## TECHNICAL MEMORANDUM

<b>Date:</b>	May 24, 2025
<b>To:</b>	Laura Baker, Friends of the Gualala River
<b>From:</b>	Greg Kamman, PG, CHG
<b>Project:</b>	24-1013 Technical Assistance to FOGR
<b>Subject:</b>	Conceptual BMP Recommendations to Caltrans Streetscape Project

FIGURE 4: Existing drainage alignments associated with the southern portion of the Streetscape Project.

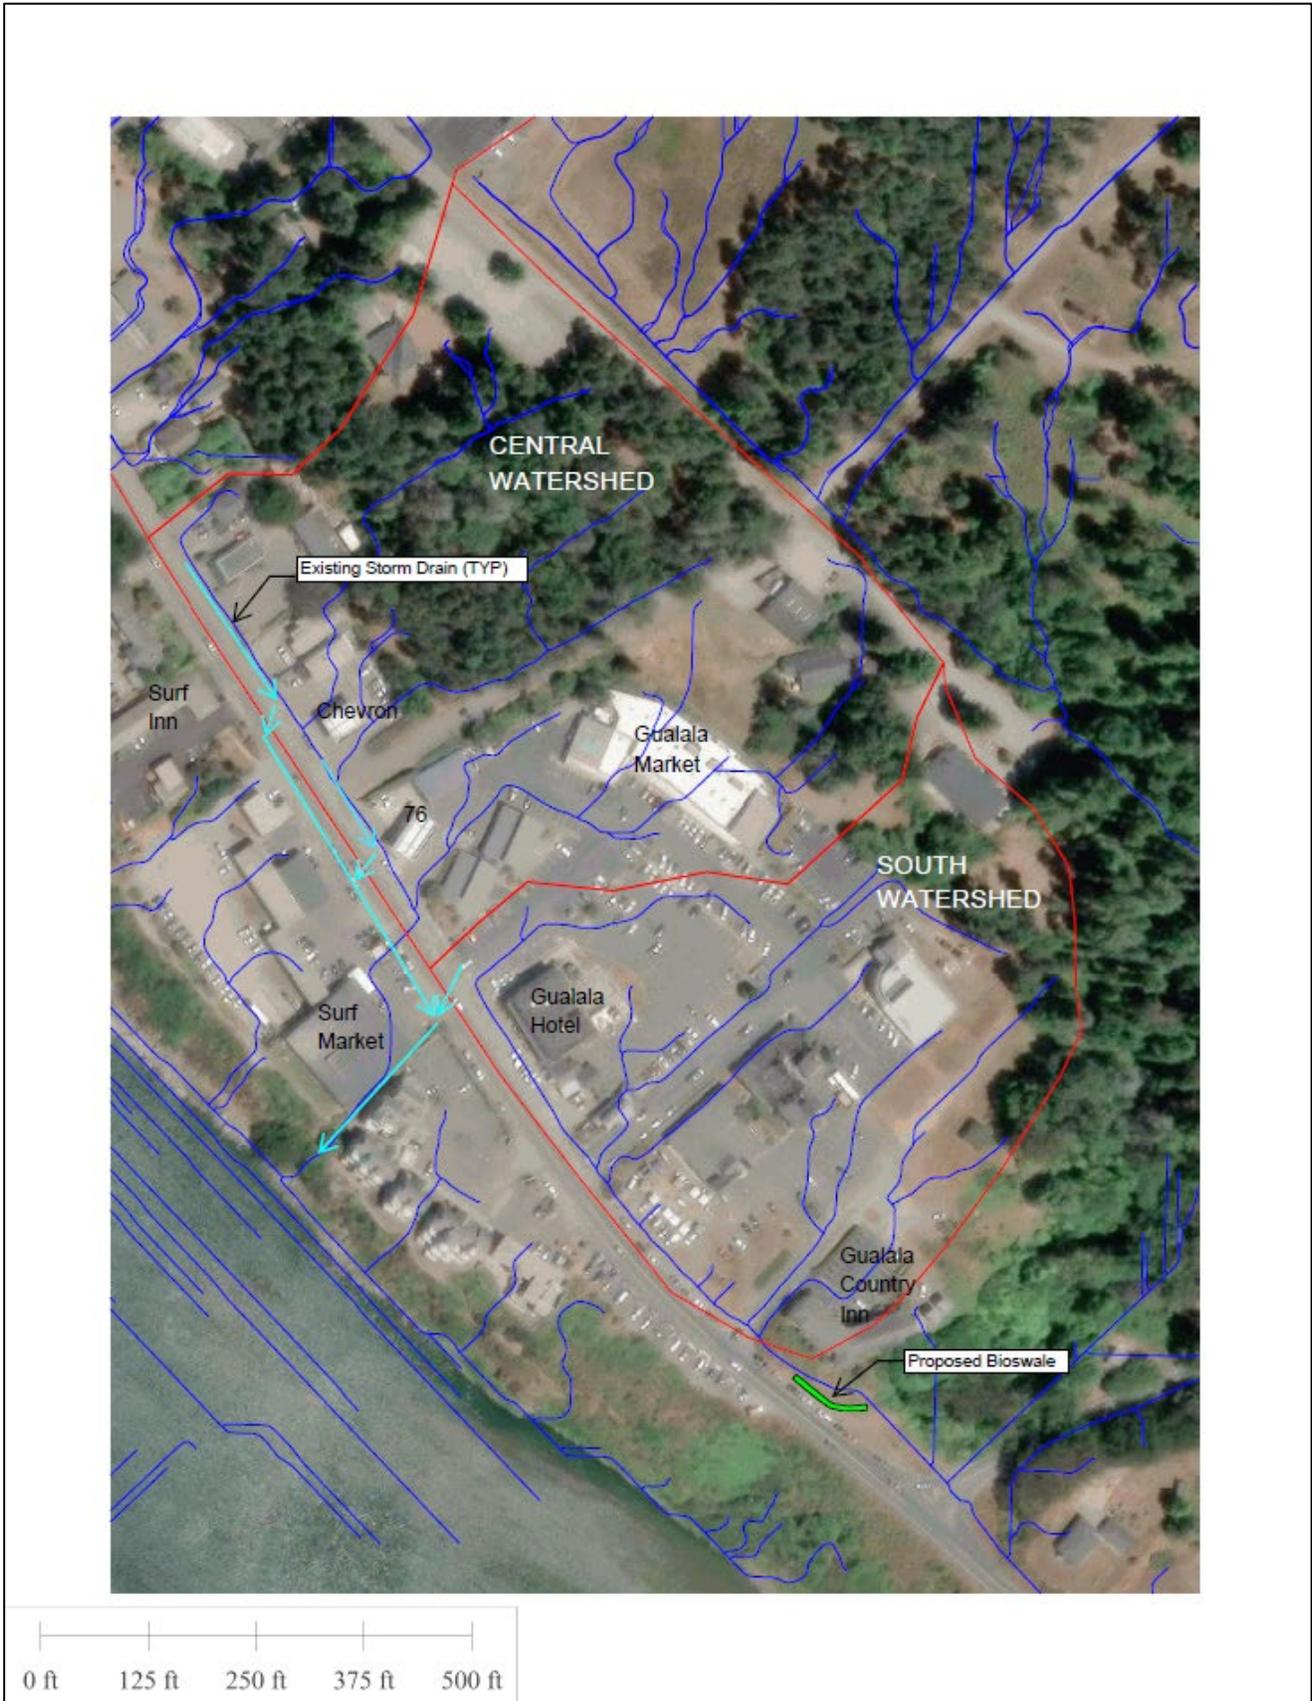
**Figure 4** is a map focused on the Central and South Watershed drainage areas and pathways. It also indicates the proposed location of the Caltrans bioswale behind the Gualala Country Inn at the south end of the Project, which is intended to reduce pollutant loads from the Project. An important finding from this study is that the bioswale would only receive and treat runoff from only the South Watershed. However, as presented above, the elevated concentrations of 6PPD-q identified by The Stream Teams water quality monitoring program are sourced from the Central Watershed. There are no BMPs proposed in the Streetscape Project to treat runoff from the Central Watershed.

FIGURE 5: Conceptual BMP recommendations to the southern portion of the Streetscape Project.

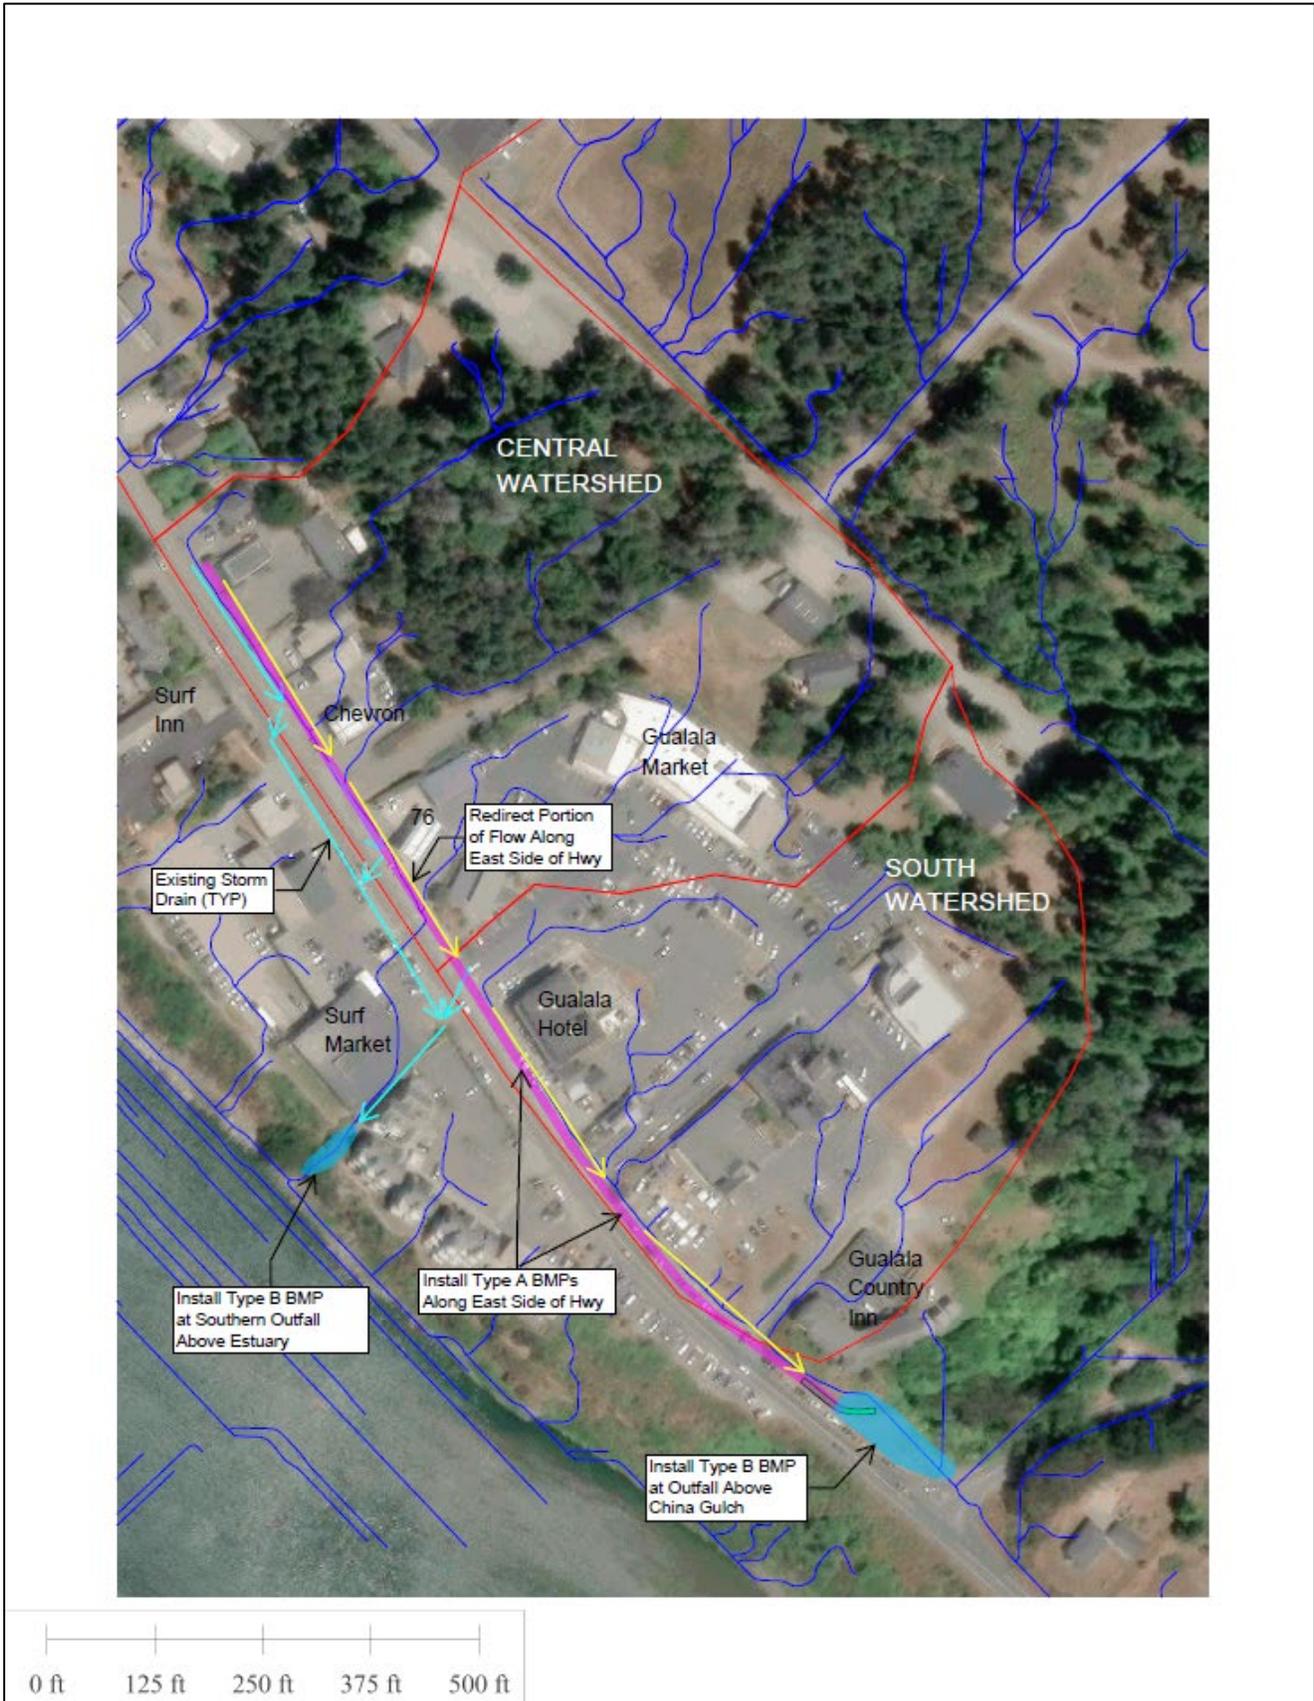
Based on these findings, cbec has identified conceptual BMP measures that could be incorporated or complement the Streetscape Project to reduce pollutant loadings to the estuary from the Central Watershed (see **Figure 5**). The assumptions and strategies behind these BMP measures follow.

Given Project right of way width constraints, the largest area that can accommodate additional or expanded BMPs is located within and beyond the proposed bioswale between the Gualala Country Inn and Old State Highway (**Figure 5**). This area would outfall into China Gulch Creek. The BMPs that could be incorporated into this area include an infiltration basin, bioretention basin, and/or bioswale (hereafter referred to as Type B BMPs).

The main goal of this conceptual BMP plan is to treat runoff from the Central Watershed. There probably isn't enough room to install an infiltration- or retention-basin in the southern outfall to the estuary (behind the Surf Market) that can handle/treat all the runoff from the Central Watershed. Thus, the existing Project underground storm drain system could be modified to reduce the amount of water directed from east to west across State Route 1 and into the southern outfall. This could be done by segregating flows and directing them through a series of linear BMPs along the east side of State Route 1 down to the Type B BMPs at the China Gulch Creek outfall. Examples of linear BMPs (referred to as Type A BMPs on **Figure 5**) that could be constructed along the east side of State Route 1 include: Design Pollution Prevention Infiltration Areas (DPPIA); infiltration basins; infiltration trenches; biofiltration strips/swales; and media filters (Caltrans, 2023). In addition, by reducing the amount of runoff directed to the southern outfall above the estuary, there may be sufficient room to install Type B BMPs at this location.
